Our Ref: KE-KETRACO-413024-CW-RFB

Clarification No. 2

RE: Clarification No. 2 to the Bid Document for the Design, supply, installation and commissioning of STATCOMs and shunt devices on the KETRACO Network at Suswa and Rabai Substations (Lot 1 - Suswa 400/220 kV Substation & Lot 2 - Rabai 220/132 kV Substation) (KE-KETRACO-413024-CW-RFB)

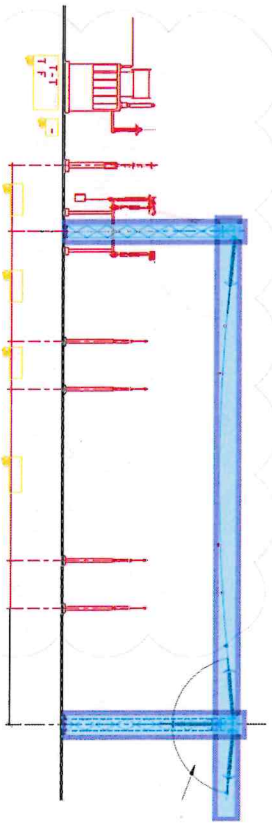
15.	<p>With reference to Part 2A (Voltage source converter redundancies requirement), Clause 2.8:</p> <p>Further clarification is requested regarding the following requirement:</p> <p>"The number and rating of IGBTs/IGCTs used to form the IGBT/IGCT Modules and converter assembly shall meet the overall performance requirements. The valves</p>	<p>The Bidder must design the converter with additional series levels or redundancy per arm, so that a fault/failure in a portion of the modules does not impact rated MVAr delivery.</p>

<p>shall have sufficient margin to enable rated output to be maintained continuously with the higher of:</p> <ul style="list-style-type: none"> • 15% of the total number of series IGBT/IGCT levels in the converter short-circuited • One (1) IGBT/IGCT per power module defective"

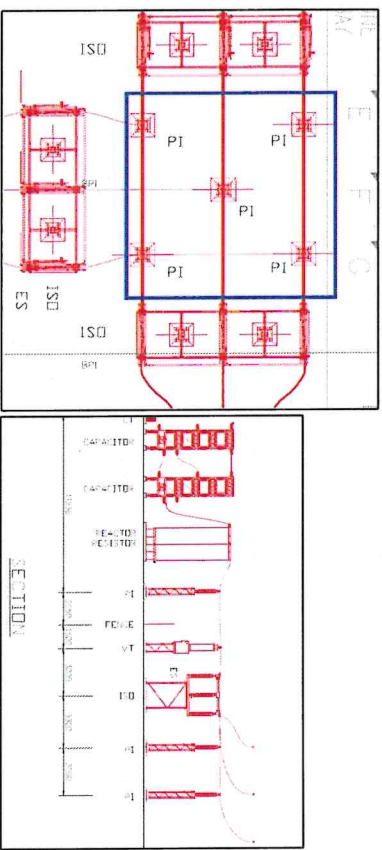
34.	As per Part 2-B (Bid Drawings), Pg. 4 of 26, the section drawing suggests a 250/226 aluminium alloy tubular conductor is used for the existing 400kV line. We plan to use the same for Lot-1 at Suswa Substation; please confirm if this is correct.	For bay/object conductors Bidders are required to select conductors to suit the rating of the equipment provided or other equipment ratings in the bay. Bidders to also match existing busbar conductor and tubes when extending busbars

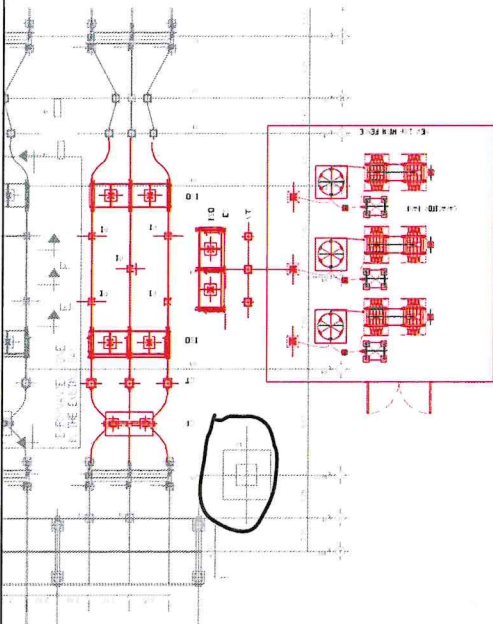
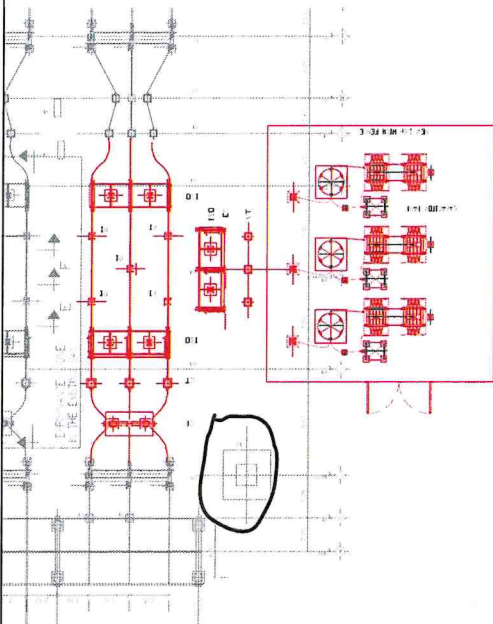
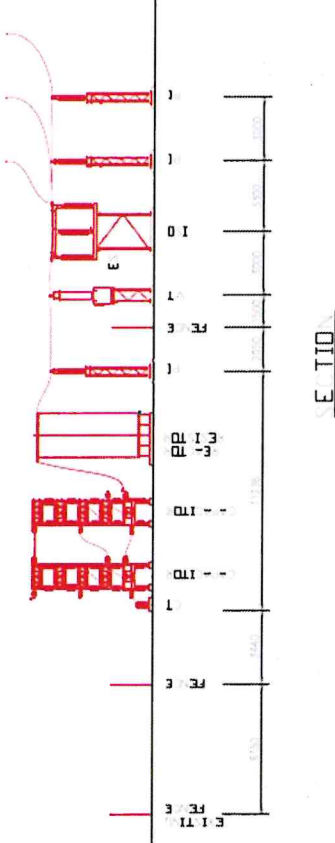
With reference to Part 2-B (Bid Drawings), Pg 17/26. As per the equipment plan, there are 5 nos. of Post insulators indicated between two disconnectors. However, the same quantity of Post insulators is not indicated in the section drawings. We request the employer to kindly clarify the exact requirement of Post insulators.

The quantity will be dependent on the Bidders design subject to the approval of the Employer. There is a relevant line item in the price schedules, and this shall be deemed to be inclusive of all the required quantities.

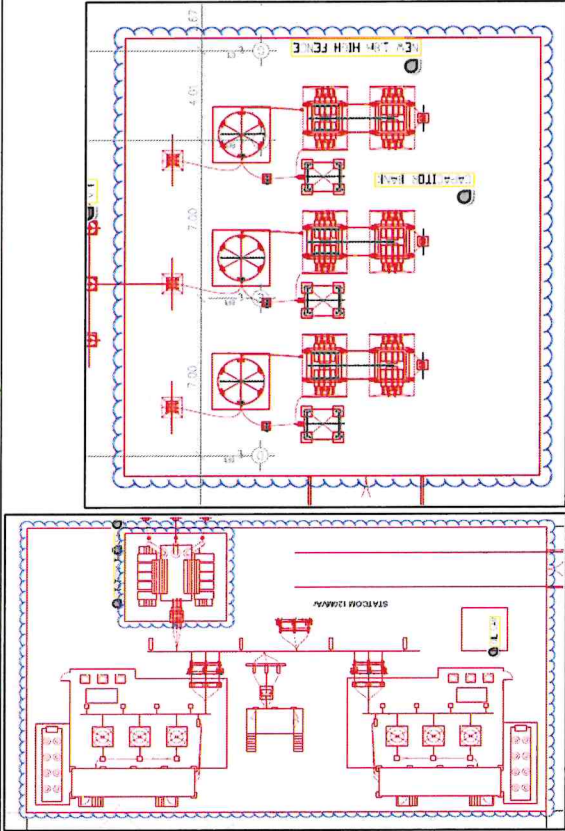
With reference to Part 2-B (Bid Drawings), Pg.17/26, kindly provide the height of existing lightning mast as indicated in the above picture to verify the lightning protection for the new area.

The final lightning design is based on a detailed lightning study and subject to the Employers approval. Any new lightning protection requirements is deemed to be part of the Bidders scope.

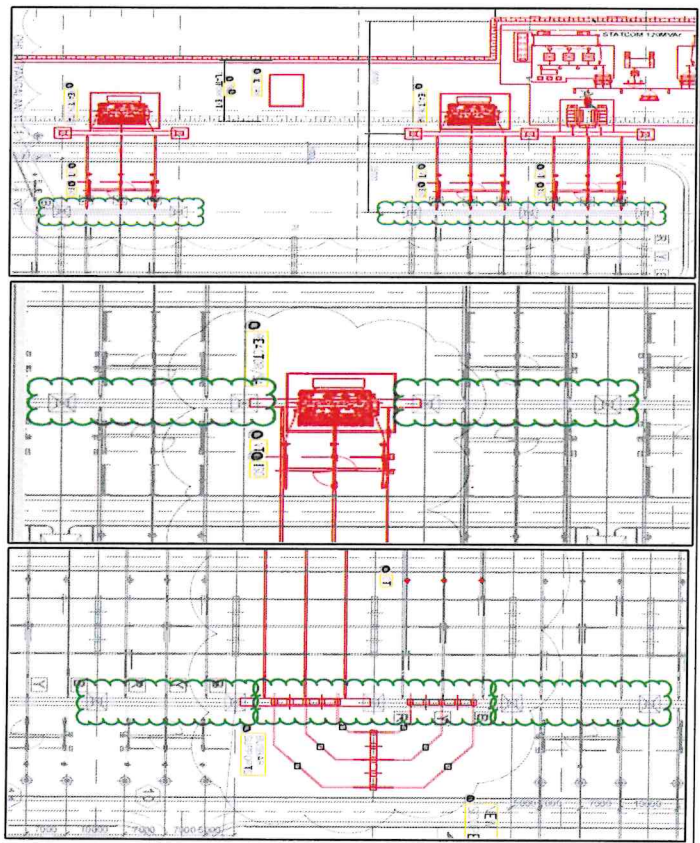
45.	<p>As per the referenced picture, it appears that the bus for the current scope is already available, and only the feeder needs to be added. However, based on the layout and site photos, we understand that the existing bus requires extension to accommodate the new feeder.</p> <p>Could you please confirm if this understanding is correct?</p>	<p>We confirm that the busbar should be extended by the Bidders in order to accommodate a new 220 kV bay.</p>
